CERTIFICATE OF APPROPRIATENESS

Property: 1528 Allston Street, Lot 19, Block 142, Houston Heights Subdivision. The property includes a historic 1,949 square foot house situated on a 6,600 square foot (50' x 132') interior lot.

Proposal: Alteration – Construct a 1,092 square foot addition on top of and to the rear of a 1,949 square foot 1½ story contributing residence.

Recommendation: Denial - does not satisfy criteria

NORTH SIDE ELEVATION

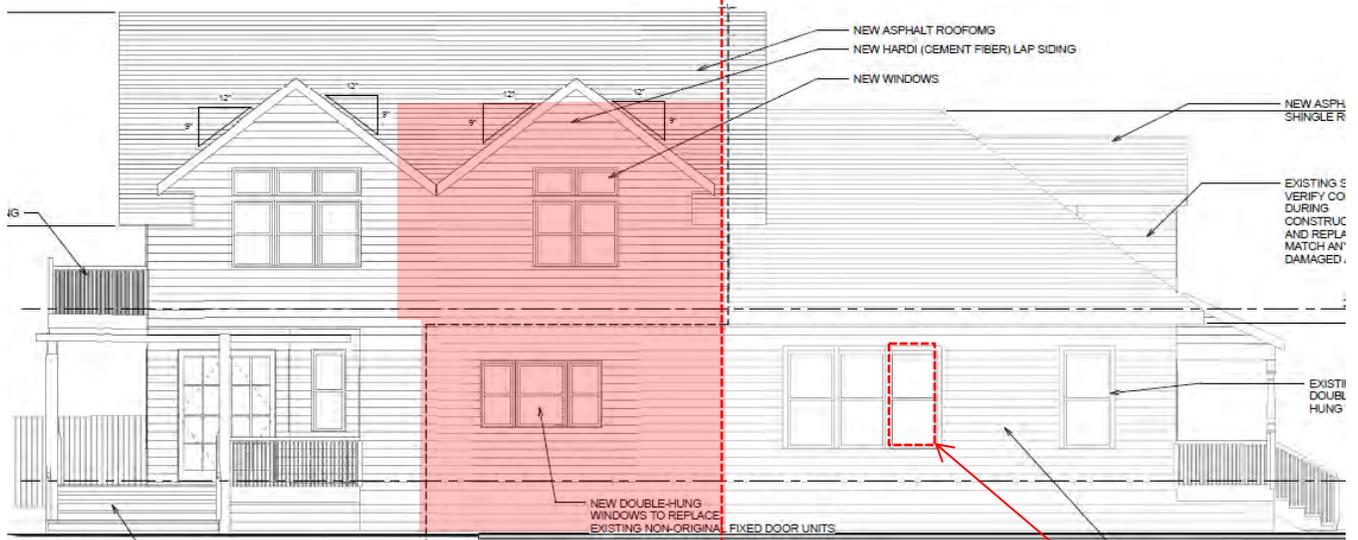
<i>The addition of a second level on top of the rear 18'-8" of the existing home alters the character of the residence from a modest one story home to a larger two story structure.</i></p> |

<i>The house's one story stature is a character defining quality of early 20th Century Folk Victorian residences. Constructing a second story over a large portion of the existing home undermines this distinguishing quality of both the house and the historic district.</i></p> |

<i>The proposed second floor addition will result in the loss of the rear 18'-8" of the existing residence's roof structure. In addition, the placement of a second floor jeopardizes the essential form and integrity of the structure, as the historic wall framing is often heavily altered or replaced in order to carry the added weight of the second floor.</i></p> |

<i>The proposed second floor addition is incompatible with the one story character of the existing home. In addition, the placement of the addition on top of the existing structure results in the removal of the existing roof structure, as well as jeopardizes the integrity of the existing structural wall material.</i></p> |

Staff finds that if the proposed addition were revised to move back the encroachment on the existing house by 9' it would satisfy criteria 1, 4, 8, and 9. The addition would be less visible from the street and would result in a loss of less historic fabric.
